PARK  $\mathbf{O}$ S SITE DEVELOPMENT PLAN LOT 2 CLAREMONT BUSINES FILING NO. 2 QUALITY BRAND GROUP CO, S 80

## LANDSCAPE PLAN

File number: PPR2345 REVISED; information added

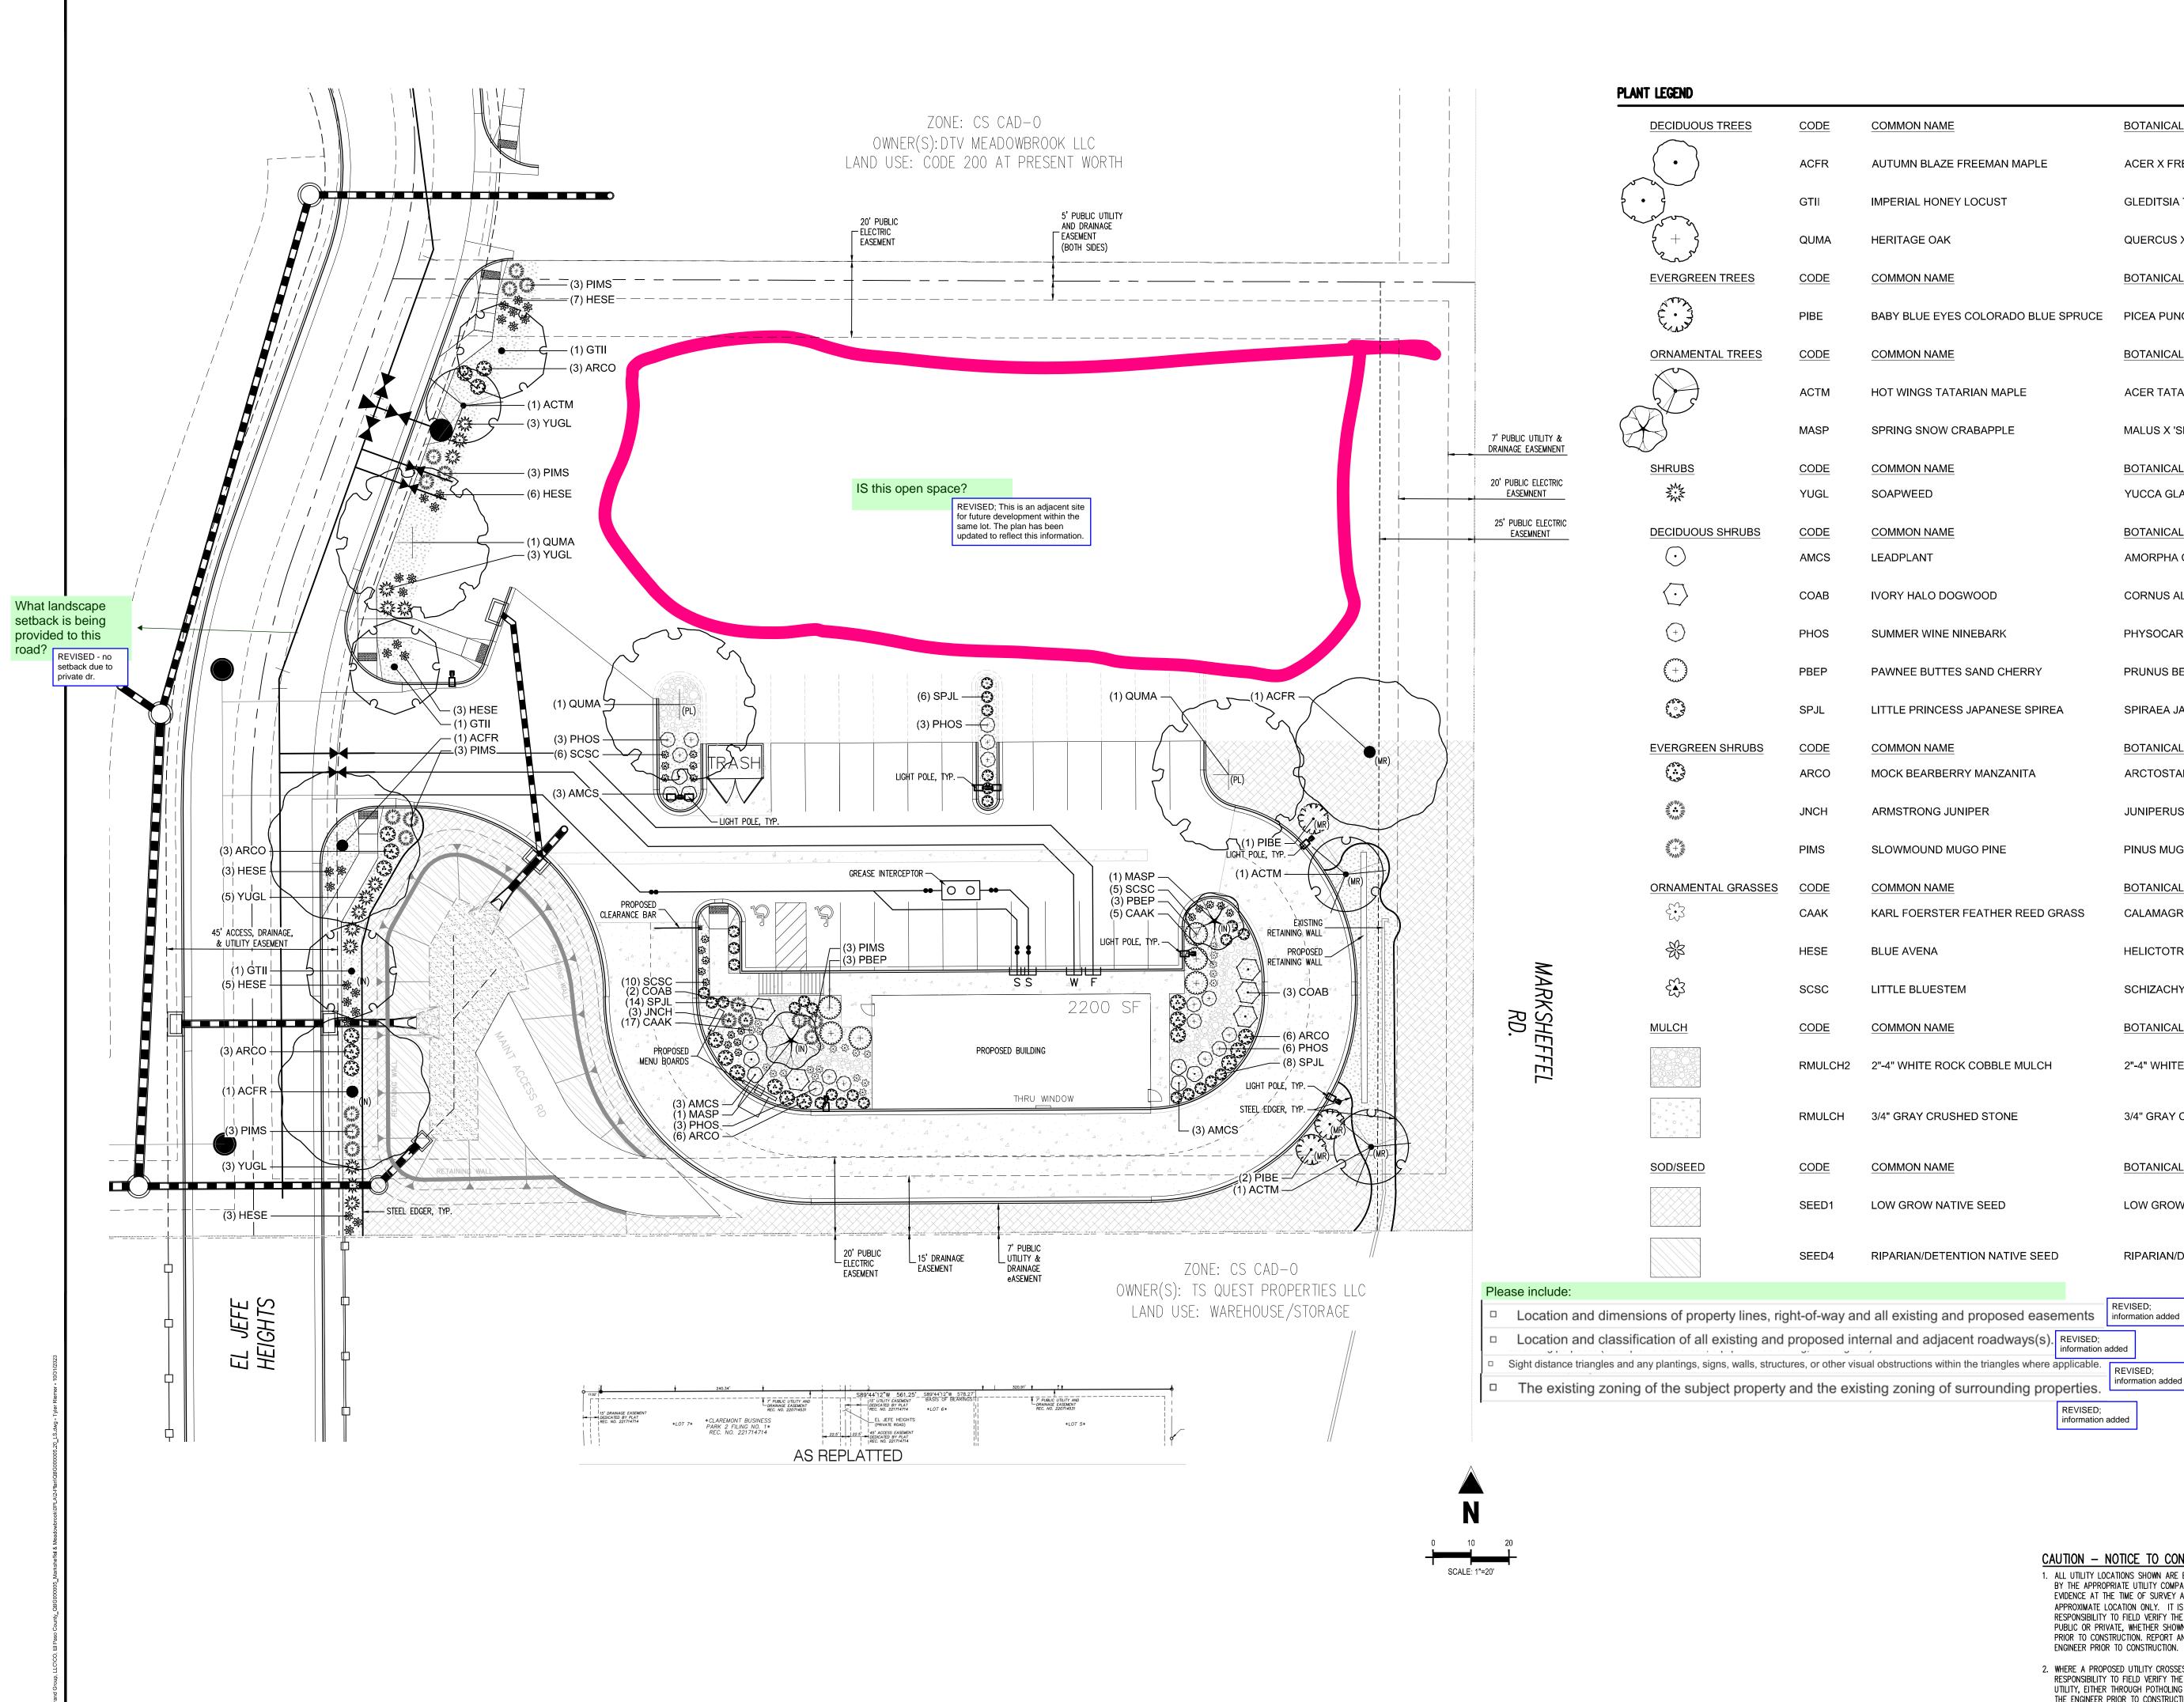
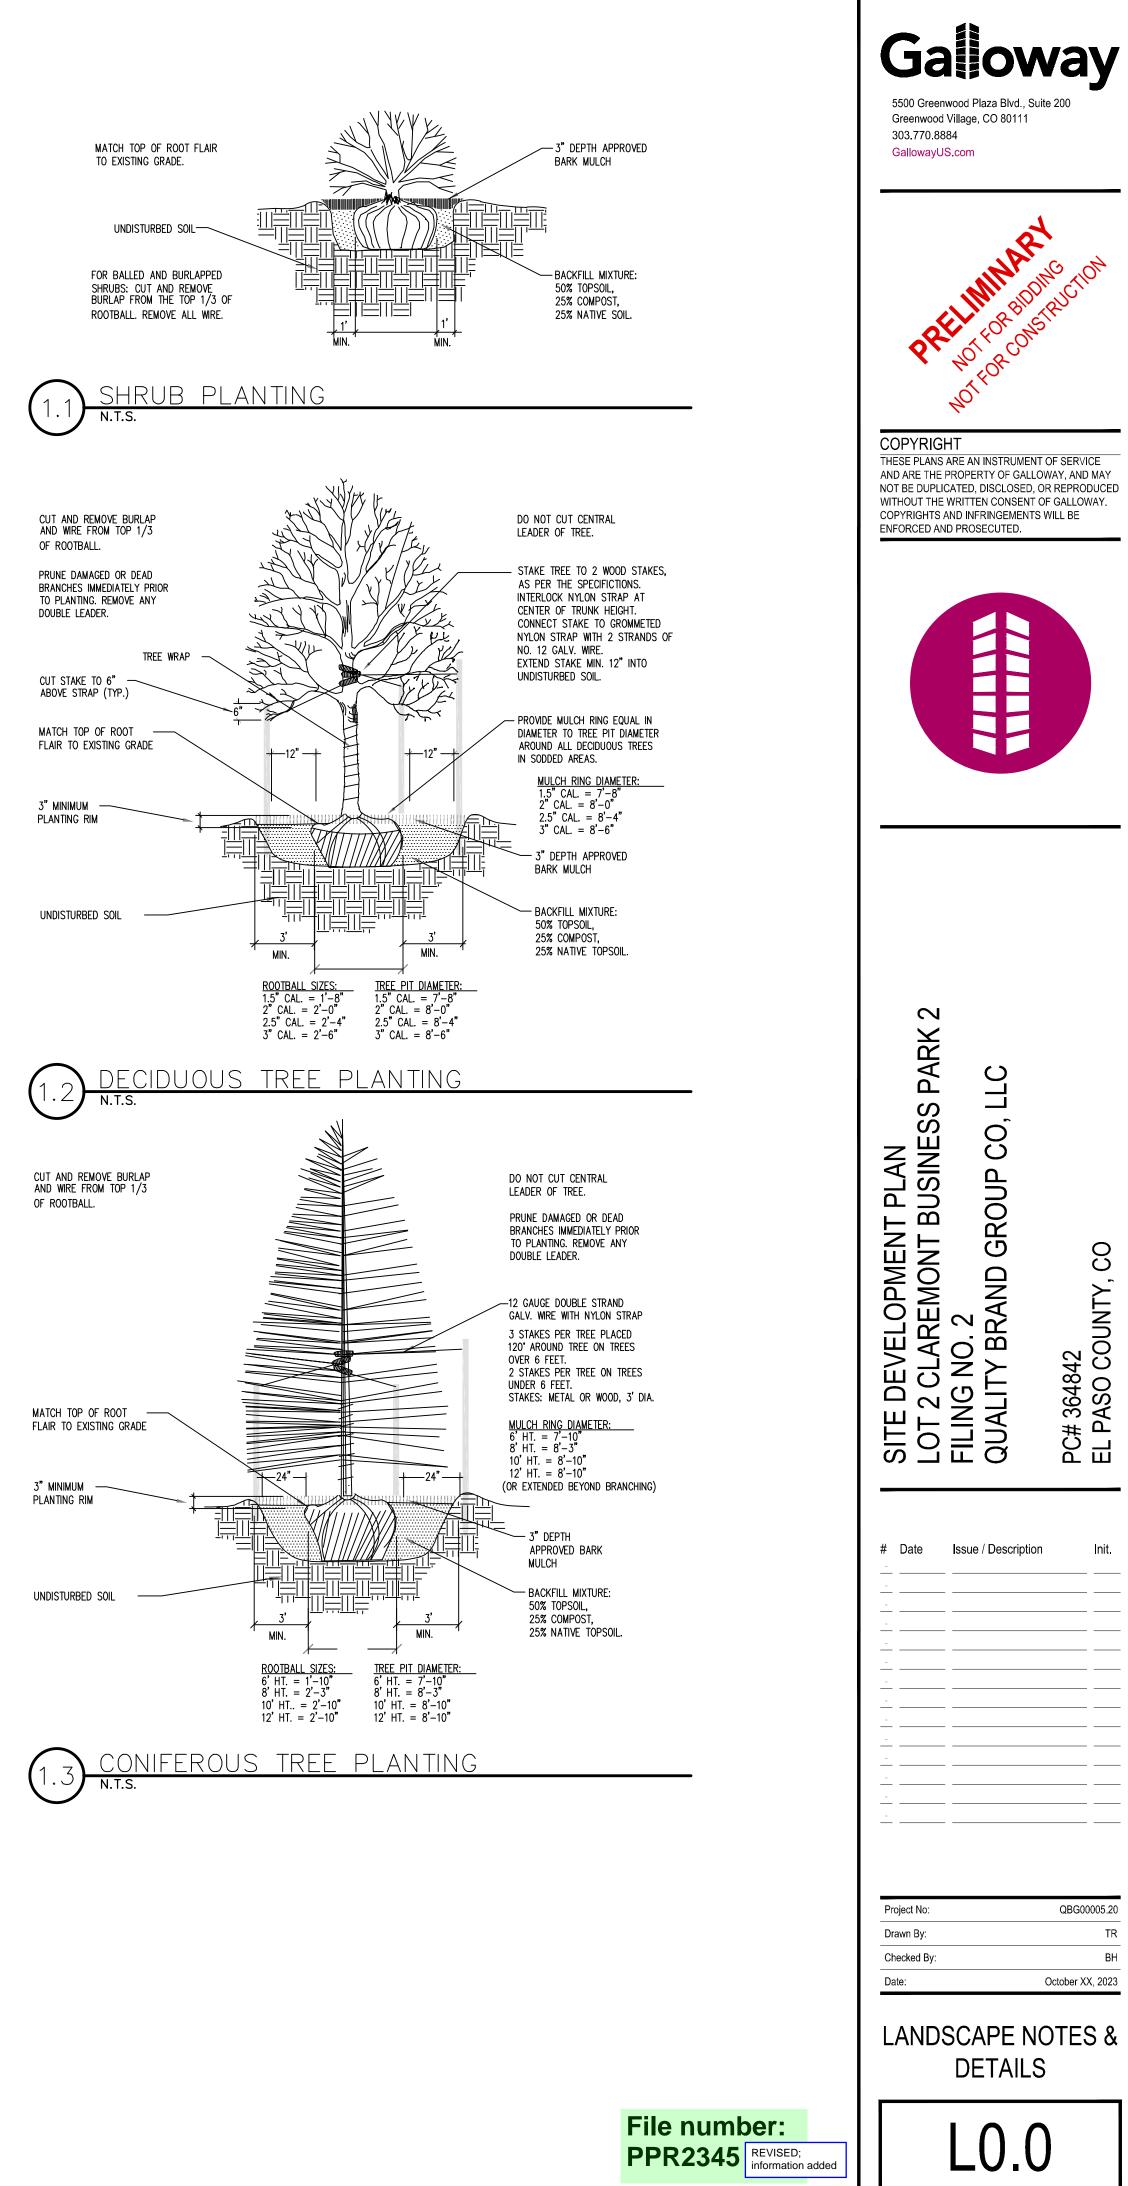
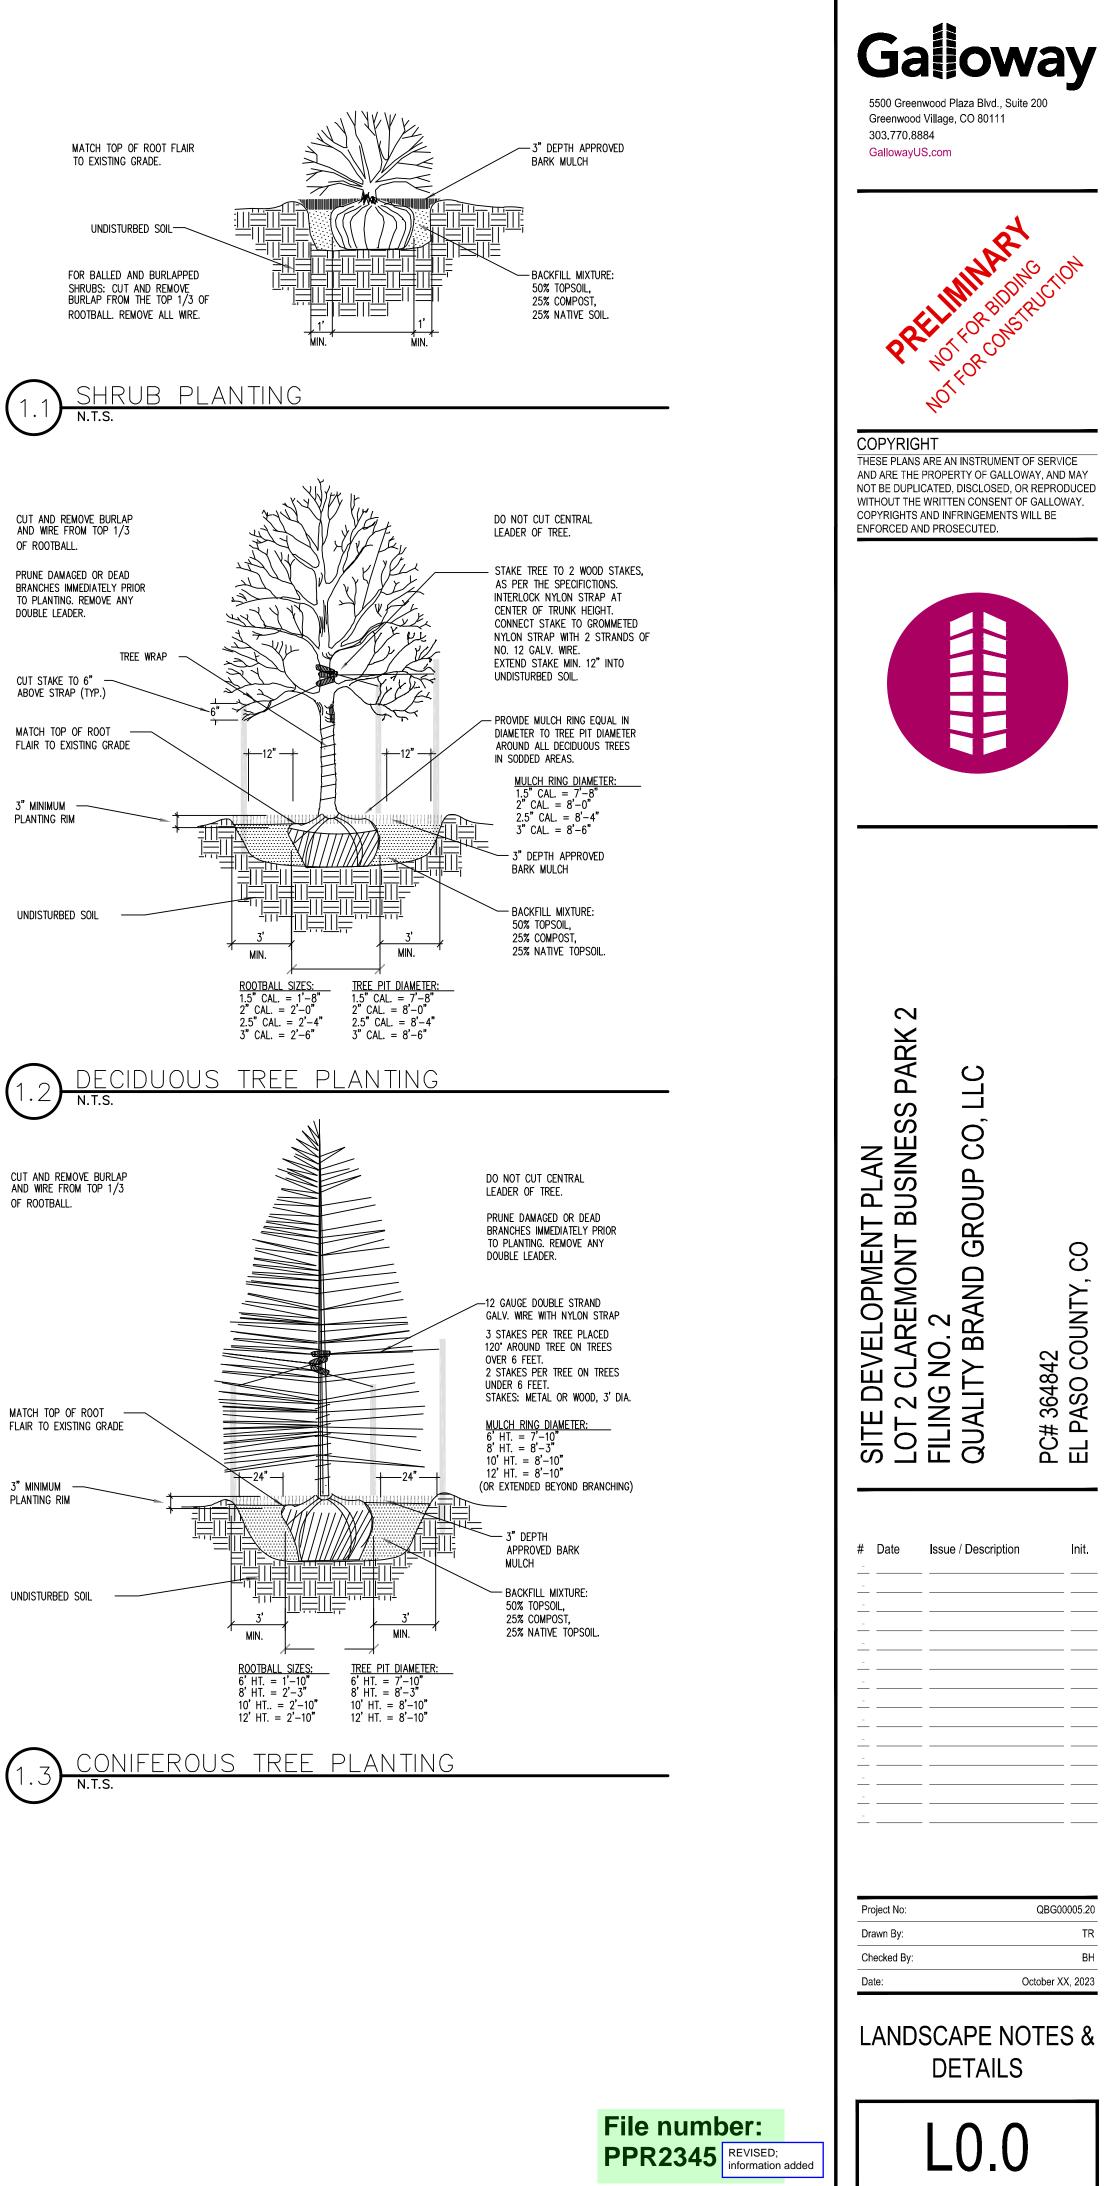
EMAIL: GEORGIANNE2@MSCIVIL.COM	-lot size information added	
		<b>O</b>
PLANTING NOTES		
1. ALL WORK SHALL CONFORM TO ALL APPLICAE	BLE STATE AND LOCAL CODES, STANDARDS, AND SPECIFICATIONS. URE. THE CONTRACTOR SHALL BE RESPONSIBLE FOR HIS OWN TAKEOFFS AND QUANTITY CALCULATIONS. IN THE EVENT OF A	S
DISCREPANCY BETWEEN THE PLAN AND THE L OF THESE DISCREPANCIES. MINOR ADJUSTME	LANDSCAPE LEGEND, THE PLANT QUANTITY AS SHOWN ON THE PLAN SHALL TAKE PRECEDENCE AND NOTIFY THE LANDSCAPE ARCHITECT INTS TO THE LANDSCAPE MATERIAL AND LOCATIONS MAY BE PROPOSED FOR CITY CONSIDERATION AT THE CONSTRUCTION DOCUMENT	ć:3
	conditions. However, there shall be no reduction in the number and size of materials. If the locations of existing and proposed utilities, and shall be responsible for any damage to the utilities and/or any	张
INJURY TO ANY PERSON. THIS DRAWING IS	PART OF A COMPLETE SET OF CONTRACT DOCUMENTS. UNDER NO CIRCUMSTANCES SHOULD THIS PLAN BE USED FOR CONSTRUCTION TIONS OF UTILITIES ON SITE AND REVIEW ALL RELATED PLANS AND DOCUMENTS.	Ê

REVISED; information added information added REVISED; information added
